Z-60
(2016)

Larry D. Neese, PLS ENGINEERS PLANNERS SURVEYORS 194 Cadence Trail Canton, Georgia 30115 (770) 428 - 2122 E-Mail: Lneese2235@aol.com	Preliminary Subdivision Layout Richard Duncan 2712 Bob Bettis Road Land Lots 559 & 594 16th District 2nd Section Cobb County Georgia	SHEET
	Date: May 4, 2016 Scale: 1"=40'	Job No. 160025

PETITION NO: Z-60

ZONING COMMENTS:

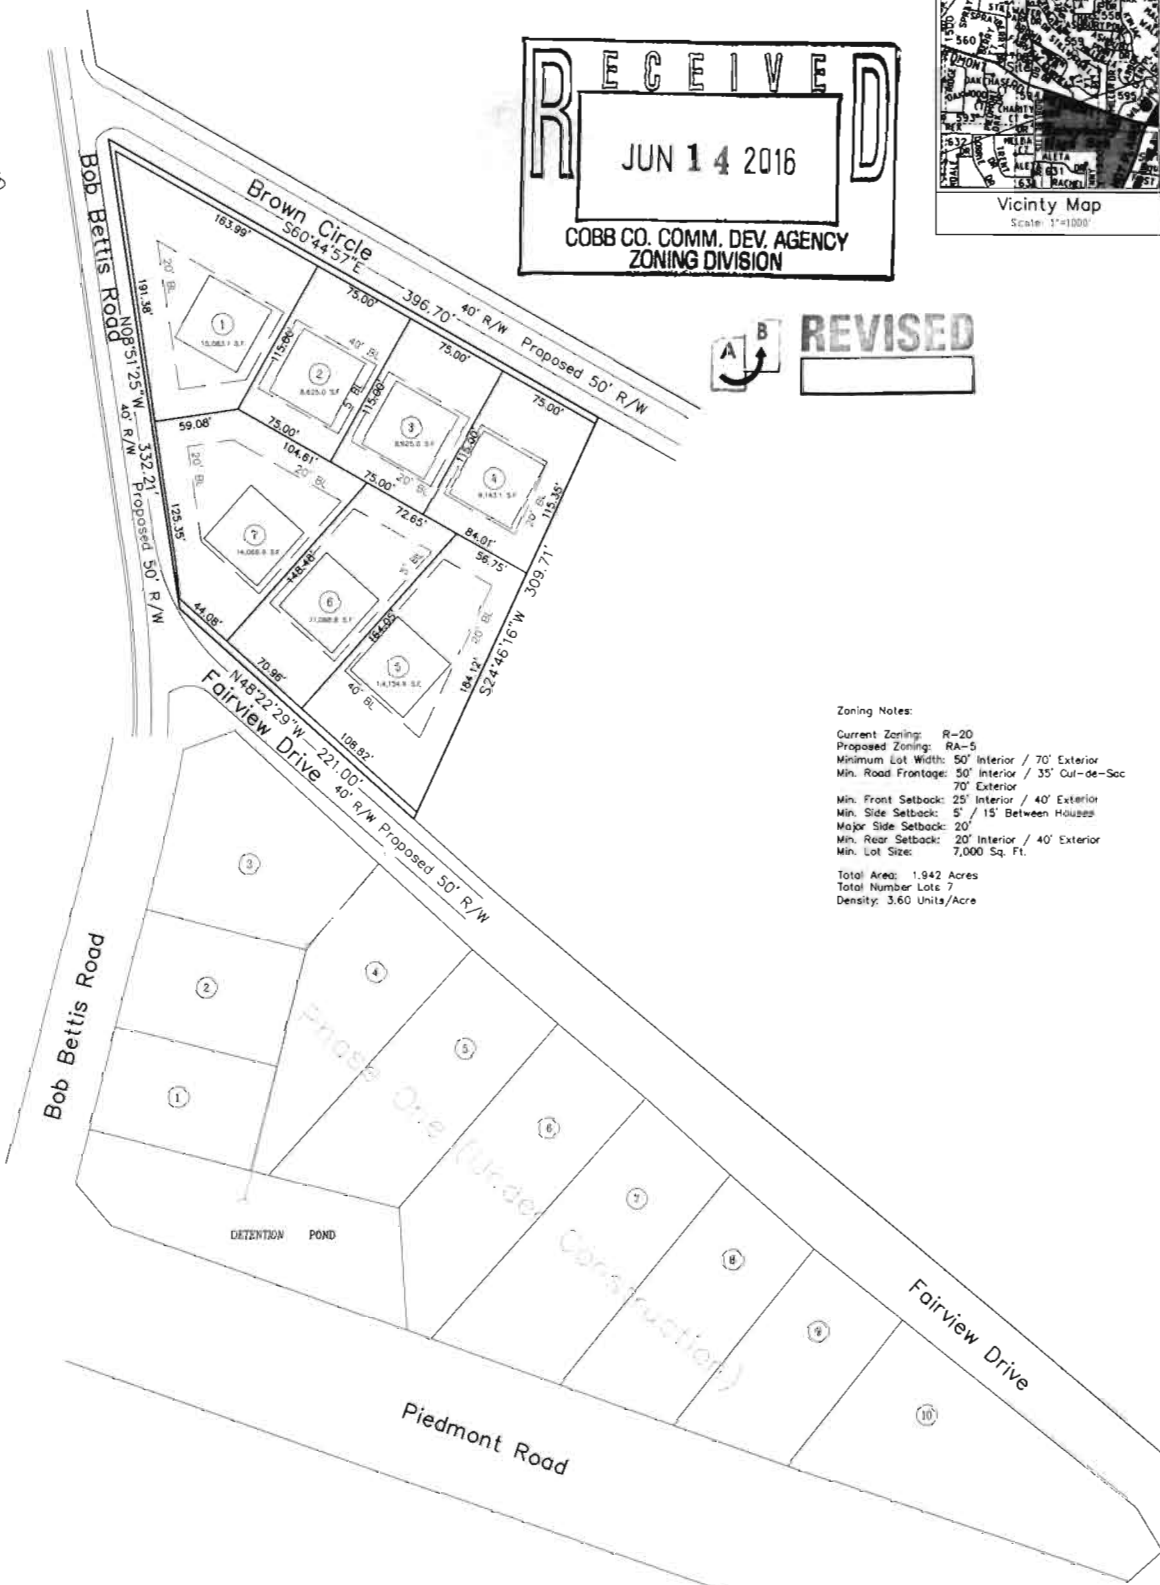
Additional Comments: Fairview Dr water main extension may be required to serve lots 5 & 6

Additional Sewer available w/o easement via sewer extension by Duncan subdivision under construction
Comments: south of Fairview Dr.

- No Stormwater controls shown _____
- Copy of survey is not current – Additional comments may be forthcoming when current site conditions are exposed.
- No site improvements showing on exhibit.

1. This site is located to the east of Bob Bettis Road between Brown Circle and Fairview Drive. The parcel is completely wooded with average slopes of less than 5%. The entire site drains to the west to the Bob Bettis Road right-of-way.
2. Stormwater management for this development is proposed to be accommodated within the facility currently under construction immediately to the south at the corner of East Piedmont and Bob Bettis Roads. The pond design must be revised to account for this additional site area.

Brown Circle is classified a local and according to the available information the existing right-of-way does not meet the minimum requirements for this classification.

Bob Bettis Road is classified a local and according to the available information the existing right-of-way does not meet the minimum requirements for this classification.

Fairview Drive is classified a local and according to the available information the existing right-of-way does not meet the minimum requirements for this classification.

Recommend applicant consider entering into a development agreement pursuant of O.C.G.A. 36-71-13 for dedication of the following system improvements to mitigate traffic concerns: a) donation of right-of-way on the south side of Brown Circle, a minimum of 25' from the roadway centerline upon redevelopment.

Recommend applicant consider entering into a development agreement pursuant of O.C.G.A. 36-71-13 for dedication of the following system improvements to mitigate traffic concerns: a) donation of right-of-way on the east side of Bob Bettis Road, a minimum of 25' from the roadway centerline upon redevelopment.

Recommend applicant consider entering into a development agreement pursuant of O.C.G.A. 36-71-13 for dedication of the following system improvements to mitigate traffic concerns: a) donation of right-of-way on the north side of Fairview Drive, a minimum of 25' from the roadway centerline upon redevelopment.

Recommend curb, gutter, and sidewalk along the frontage of Brown Circle, Bob Bettis Road, and Fairview Drive.

Recommend driveways be at least 50 feet from the intersection of Bob Bettis Road.

1. Site plan received June 14, 2016, with the District Commission approving minor modifications;
2. Water and Sewer Division comments and recommendations;
3. Stormwater Management Division comments and recommendations;
4. Department of Transportation comments and recommendations; and
5. Owner/developer to enter into a Development Agreement pursuant to O.C.G.A. §36-71-13 for dedication of system improvements to mitigate traffic concerns.
